ATTACHMENT 1  
REVISED TS PAGES

8409170403 840907  
PDR ADDCK 05000261  
P PDR

ATTACHMENT 2  
REPLACEMENT TS PAGES

**Figure 2.1-1**

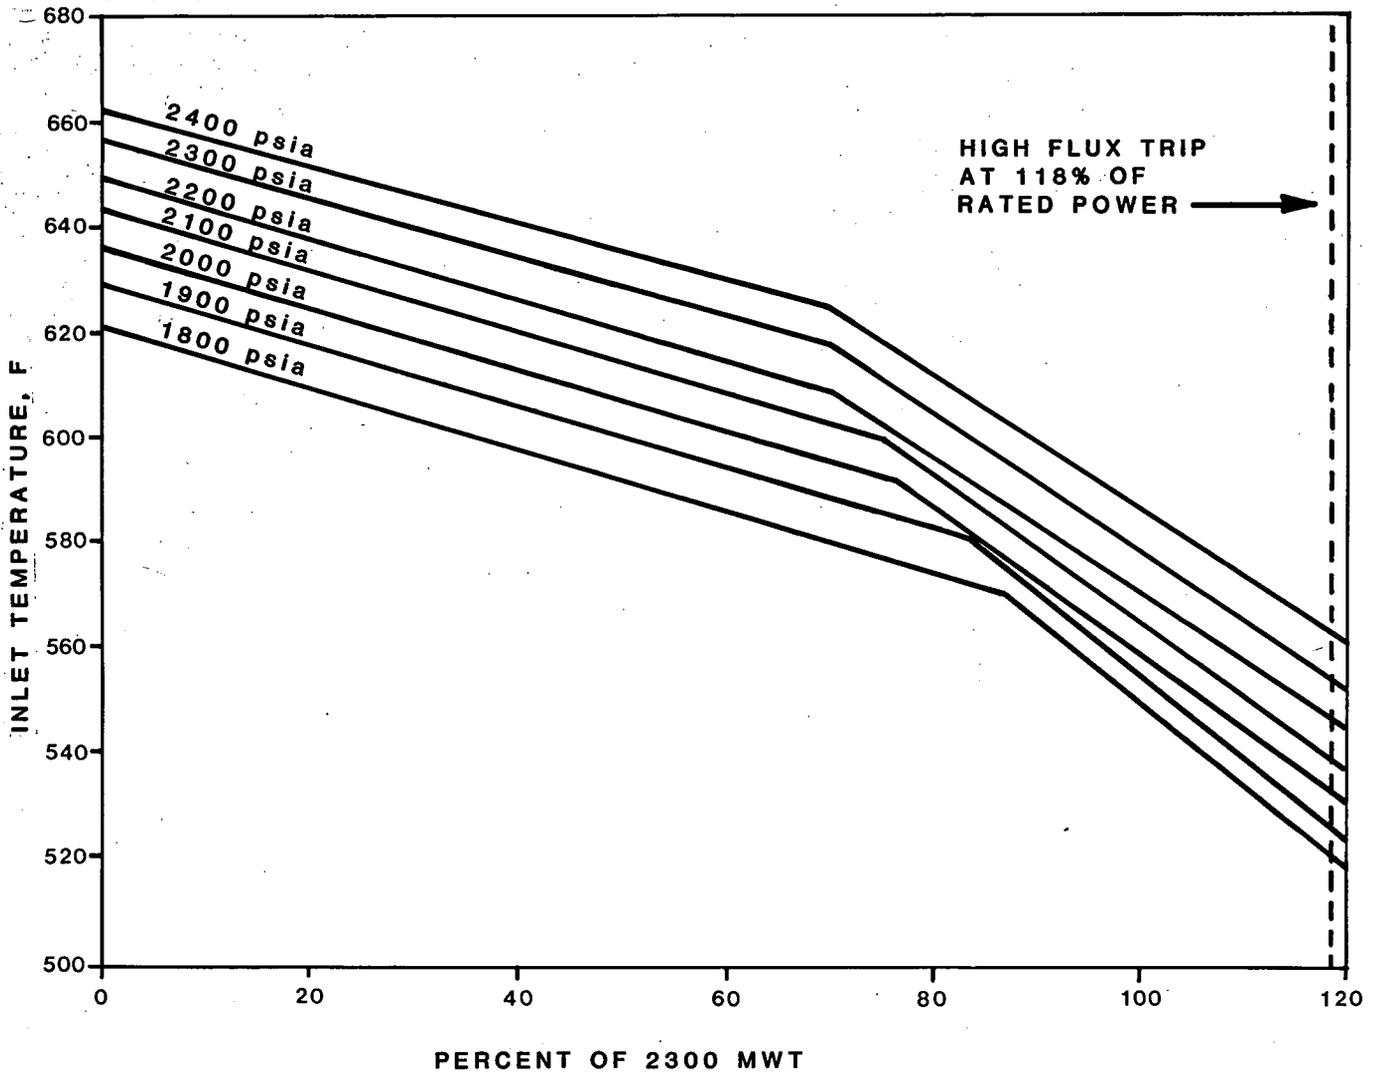
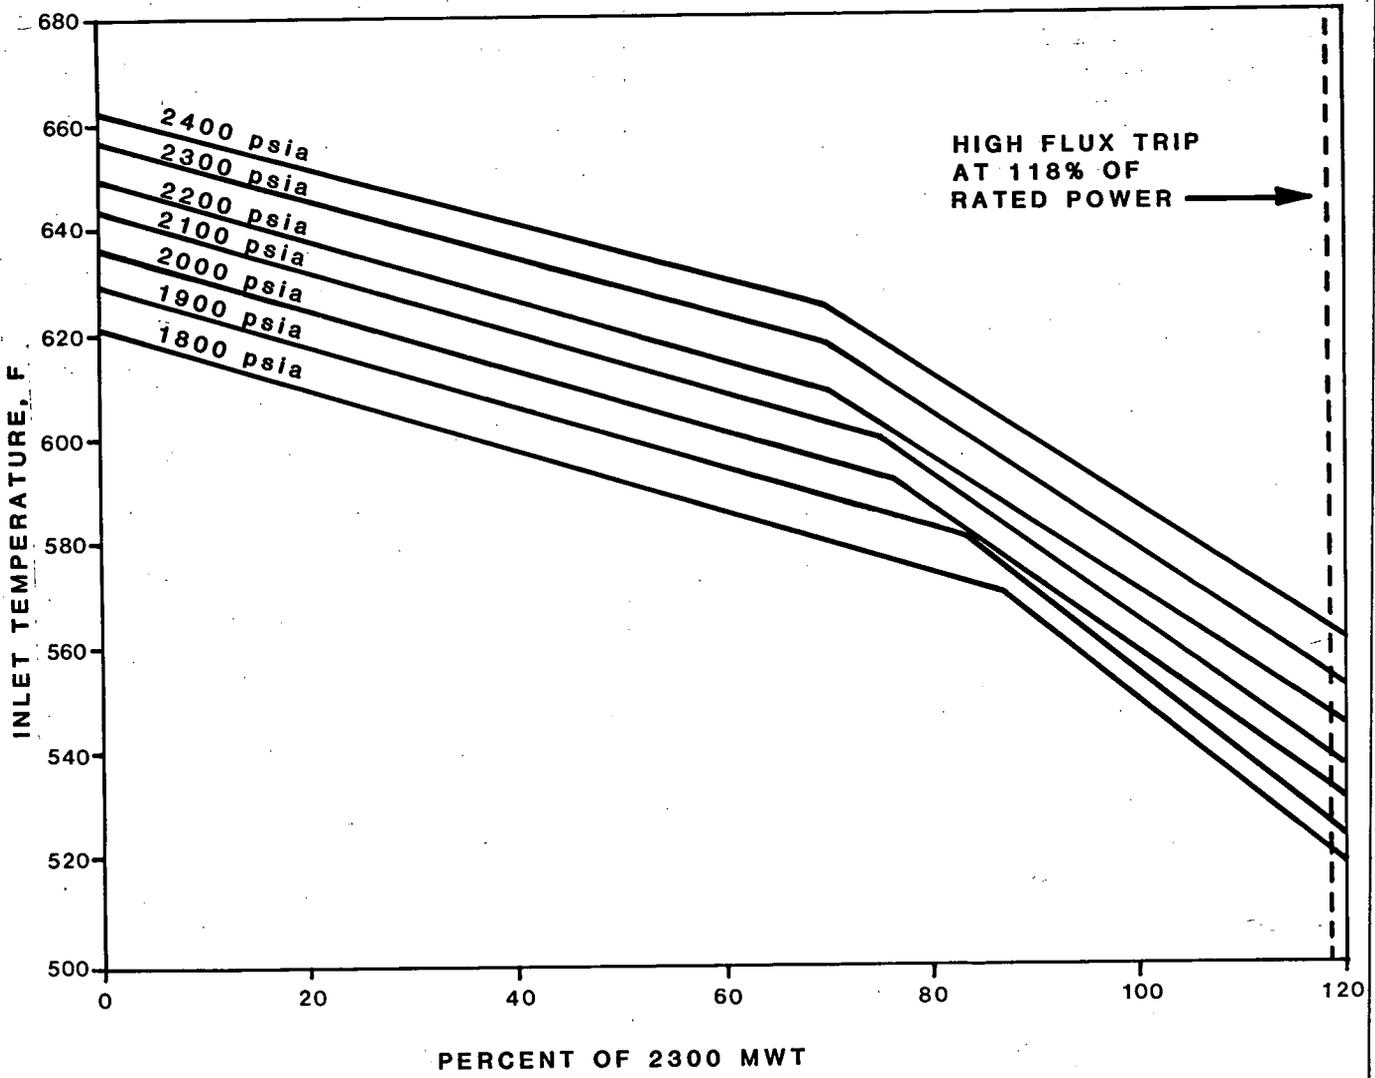
The curves of Figure 2.1-1 which show the allowable power level decreasing with increasing temperature at selected pressures for constant flow (three loop operation) represent the loci of points of thermal power, reactor vessel inlet temperature, and coolant system pressure for which the DNB ratio is not less than 1.17. The area where clad integrity is assured is below these lines. The temperature limits at low power are considerably more conservative than would be required if they were based upon a minimum DNB ratio of 1.17 but

are set to preclude bulk boiling at the vessel exit. An arbitrary upper safety limit of 118% thermal power is shown. This limit is based on the high flux trip including all uncertainties.

Radial power peaking factors consistent with the limit on  $F_{\Delta H}$  given in Specification 3.10.2.1 have been employed in the generation of the curves in Figure 2.1-1. An additional heat flux factor of 1.03 has been included to account for fuel manufacturing tolerances and in-reactor densification of the fuel.

The safety limit curves given in Figure 2.1-1 are for constant flow conditions. These curves would not be applicable in the case of a loss of flow transient. The evaluation of such an event would be based upon the analysis presented in Section 15.3 of the FSAR.

- a. The combination of thermal power level, coolant pressure, and coolant temperature shall not exceed the limits shown in Figure 2.1-1 when full flow from three reactor coolant pumps exists.

- d. The safety limit is exceeded if the combination of Reactor Vessel inlet temperature and thermal power level is at any time above the appropriate pressure line in Figure 2.1-1 or if the thermal power level, coolant pressure, or Reactor Vessel inlet temperature violates the limits specified above.
